**Norfolk Boreas Offshore Wind Farm**

# **Statement of Common Ground**

**Natural England**

Applicant: Norfolk Boreas Limited  
Document Reference: ExA.SoCG-17.D0.V1  
Deadline: 0

Figure 1 *Sabellaria spinulosa* reef mapping by the Applicant and Natural England

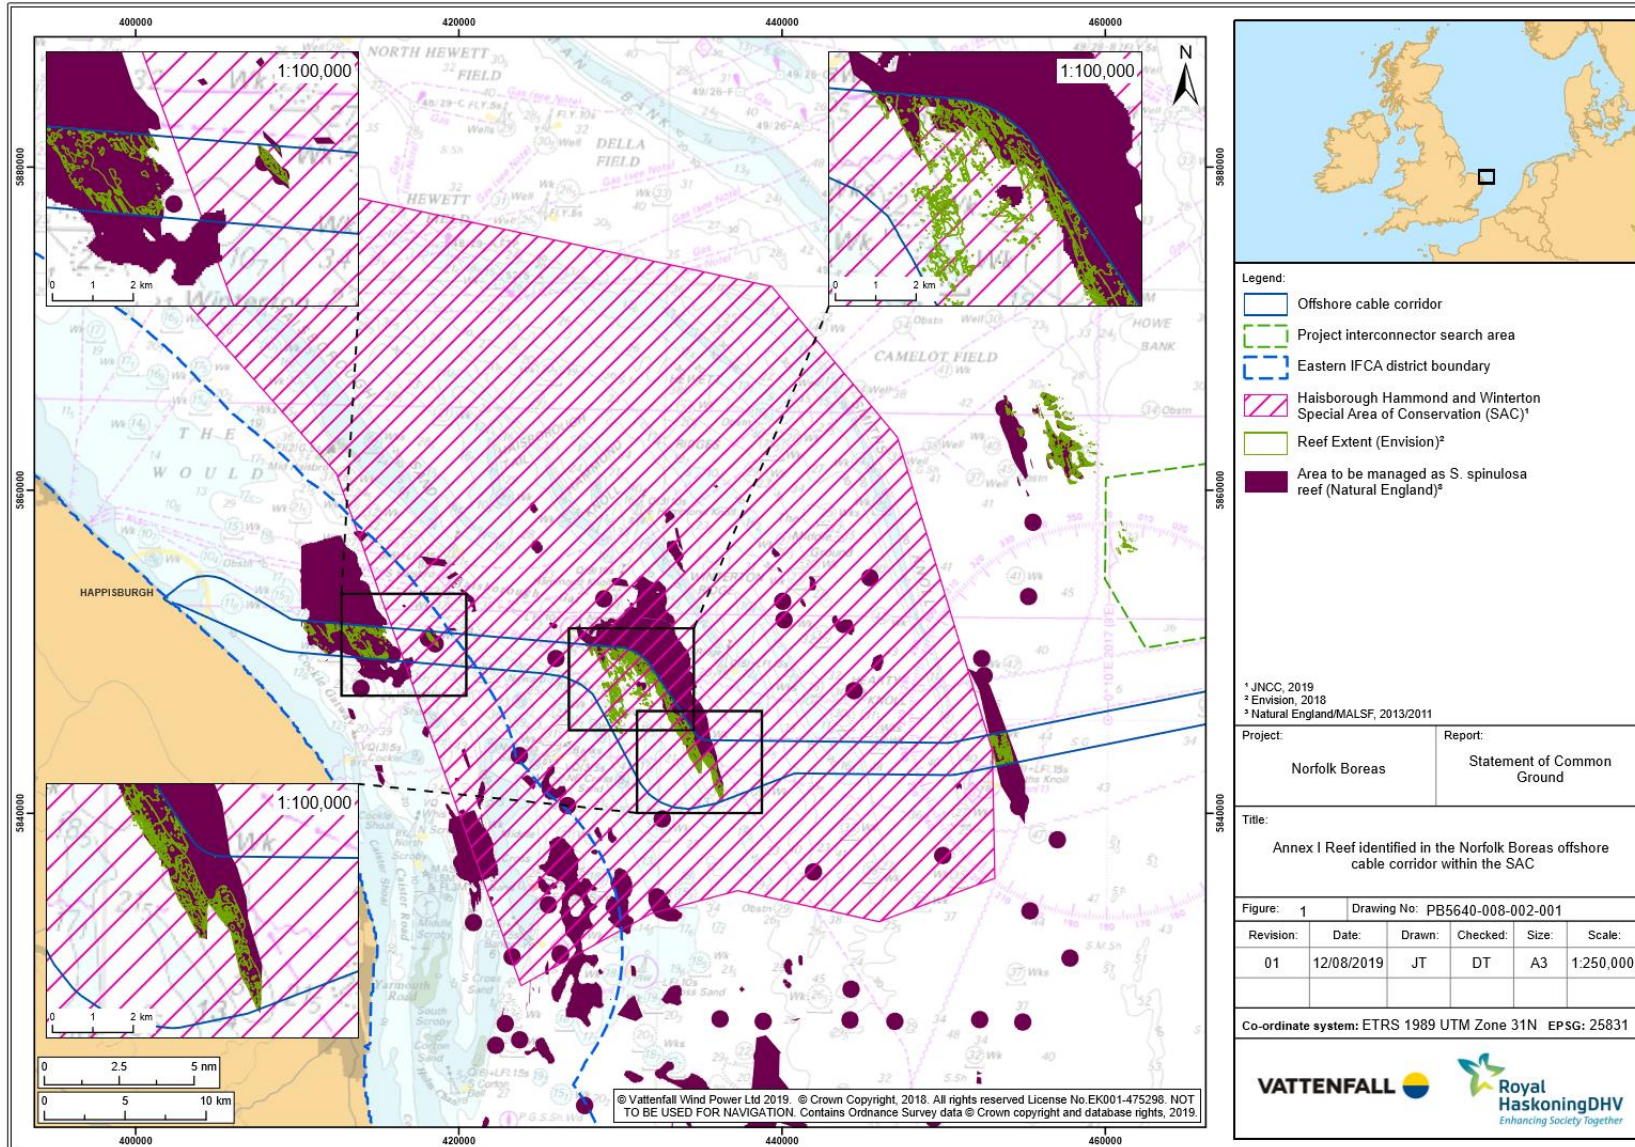
The approach to <i>S. spinulosa</i> reef mapping is appropriate to inform the EIA based on the data available.  The assessment does not discount “low reef”. It should be noted however that by definition, “low reef” is inherently patchy (with only 10-20% coverage, Gubbay	Not agreed. Natural England has uncertainty associated with <i>S. spinulosa</i> reef mapping due to the ephemeral nature of the reef, the analytical use of a range of datasets, and the confidence levels applied to reef presence Appendix 2 (RR-099)	Area for ongoing discussion

Topic	Norfolk Boreas Limited position	Natural England position	Final position
	<p>(2007)<sup>2</sup>) and therefore increases the potential for micrositing. Medium reef also has high potential for micrositing, being classified by 20-30% coverage.</p> <p>The Applicant agrees there is uncertainty associated with <i>S. spinulosa</i> reef mapping due to the ephemeral nature of the reef. The HHW SAC SIP provides a framework for further consideration of the effects on <i>Sabellaria</i> reef in the HHW SAC to be made prior to construction, based on the results of the pre-construction surveys. The surveys and the SIP will be developed in consultation with Natural England.</p>		
	<p>The mapping of potential <i>S. spinulosa</i> reef by Envision on behalf of Norfolk Boreas (and Norfolk Vanguard Limited) identifies potential reef areas which are largely consistent with areas Natural England has identified (as shown on Figure 2.1 below).</p>	Agreed	Agreed
